Access Compliance Report

Public Rights-of-Way

(Curb Ramps)

Intersection ID: 12279	Main Street: S_MINT_ST	Cross Street: W_MARTIN_LUTHER_KING_JR_BV	Location: S
ADA ID: 8D2F30F43DE0	Ramp Type: Perp	Initial Pass/Fail: Fail	Overall Compliance: No
Severity Score: 8.75			
Codes/Mitigation Info/Possible Solution		Field Measurements/Component Compliance

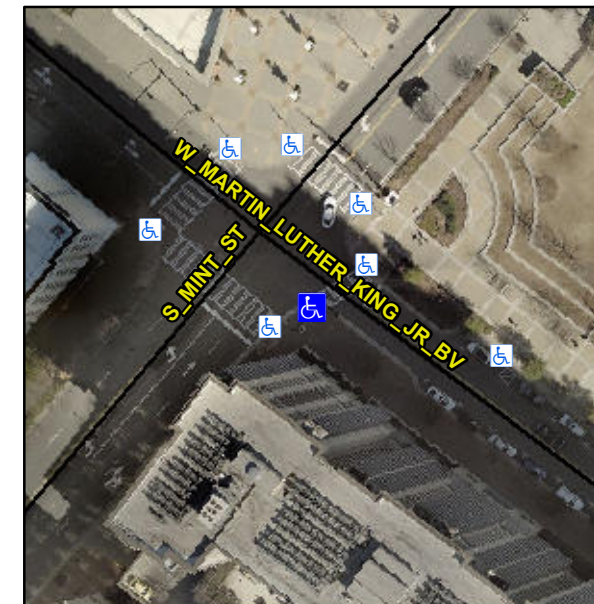
Not Found, R304.5.1

Compliance	Description	Data	Compliance	Description	Data
N/A	Ramp Length (in)	48.0	Yes	Ramp Slope (%)	7.2
No	Ramp Width (in)	47.5	Yes	Ramp XSlope (%)	0.7
N/A	Flare Type LT	N/A	N/A	Flare Type RT	N/A
N/A	Flare Slope LT (%)	N/A	N/A	Flare Slope RT (%)	N/A
N/A	Flare Traversable LT?	N/A	N/A	Flare Traversable RT?	N/A
N/A	Landing Length (in)	N/A	N/A	DWS Provided?	N/A
N/A	Landing Width (in)	N/A	N/A	DWS Contrast?	N/A
N/A	Landing Slope (%)	N/A	N/A	DWS Length (in)	N/A
N/A	Landing X Slope (%)	N/A	N/A	DWS Full Width?	N/A
N/A	Landing Curb? (Y/N)	N/A	N/A	DWS Offset (in)	N/A
N/A	Shared Landing?	N/A			
N/A	Gutter Ponding?	N/A	N/A	Gutter Slope (%)	N/A
N/A	Gutter Lip Ht (in)	N/A	N/A	Gutter X Slope (%)	N/A
N/A	Painted X Walk1?	Yes	N/A	Painted X Walk2?	N/A
	X Walk 1 Direction	To NE		X Walk 2 Direction	N/A
N/A	X Walk 1 Width (in)	95.0	N/A	X Walk 2 Width (in)	N/A
	X Walk 1 Slope (%)	0.9		X Walk 2 Slope (%)	N/A
	X Walk 1 X Slope (%)	1.9		X Walk 2 X Slope (%)	N/A

Remove & Replace Entire Ramp.
